City of Portland, Oregon
Bureau of Development Services
Land Use Services
FROM CONCEPT TO CONSTRUCTION

NOTICE OF A TYPE II DECISION ON A PROPOSAL IN YOUR NEIGHBORHOOD

**CASE FILE NUMBER: LU 15-125941 HR- NEW PATIO
ENCLOSURE AND ALTERATIONS TO A LANDMARK**

The applicant proposes exterior alterations to the Pearne Building, a local landmark and contributing resource in the Yamhill Historic District, as well as construction of a new uncovered patio enclosure at the eastern 25 feet of the existing surface parking lot.

North Elevation @ Yamhill
1/4" = 1'-0"

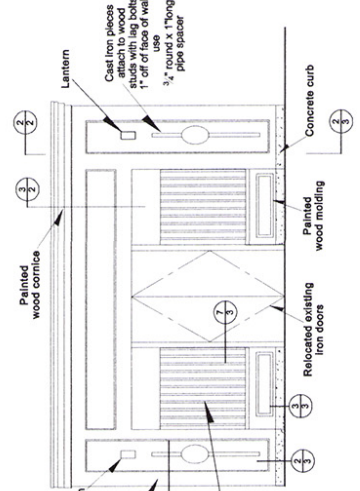
Findings: The proposed structure is 25 feet wide, and is broken into three bays, with sidewalls and open fencing flanking a central entrance at the front (north) façade. Because the structure is an open-air patio enclosure with no roof, the front façade is also relatively open, but designed to recall traditional storefront detailing. The primary feature of the front façade is the steel doors to be relocated from the east façade of the Landmark Pearne Building, thus putting these historic doors on display for pedestrians. Flanking the doors are fenced openings to provide views into the patio with adjacent columns to ground the structure and provide a backdrop for the proposed lanterns and decorative cast iron pieces. *This guideline is met.*

Findings for F and G: Cast iron pieces are proposed to be attached to the front façade to provide some decoration and reinforce the character of the historic district, which features many cast-iron buildings. The proposed light fixtures have a vintage character and will also be compatible with the proposed steel doors and cast iron pieces on the north façade. No signage is proposed. *These guidelines are met.*

Findings for B2, B6, and C12: The proposed patio enclosure is to be constructed on a portion of an existing surface parking lot. Closure of the curbcut directly north of the patio enclosure will be required by the Portland Bureau of Transportation at the time of Building Permit, thus decreasing conflicts between pedestrians and vehicles at this specific location. While canopies or awnings are typically desirable on historic and new buildings, the proposed structure is relatively stripped down and does not have a traditional storefront with solid walls and windows; therefore canopies would seem out of place on this relatively threadbare structure and would also be more easily damaged by wind were they required. Staff notes that the intent of the proposed design is to be an open-air enclosure which exposes people to the elements and will most likely feature seasonal protection at the interior. Lighting, proposed at the north façade of the new structure, as well as the increased level of activity within the patio will add a sense of

security for pedestrians. Staff notes that to ensure that the proposed light fixtures do not detract from the historic character of the district, all conduit must be routed immediately to the interior of the patio enclosure and shall not be exposed at the exterior.

With the condition of approval that the conduit for the lighting shall be routed immediately to the interior of the patio enclosure and shall not be exposed at the exterior, these guidelines are met.
